APPLICATION NO.	FILING DATE	FIRST NAMED INVENTOR	ATTORNEY DOCKET NO.	CONFIRMATION NO.
10/756,379	01/14/2004	Markku Kakko	1381-0308P	2365

Office Action Summary

Paper No:10252004
Serial Number:10756379
Filing Date: January 14,2004

FIG. 9

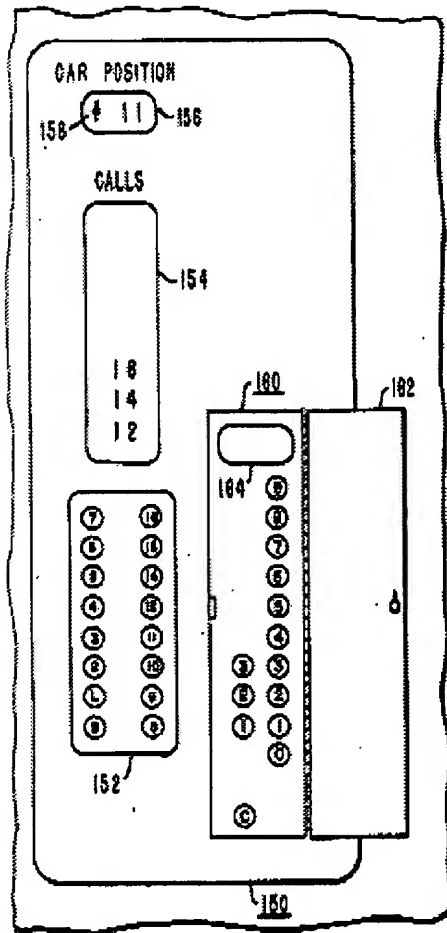
Mandel et al teaches in figures 1-10, an elevator display/operating system.

Destination floors 154,178 displayed in car and on floor.
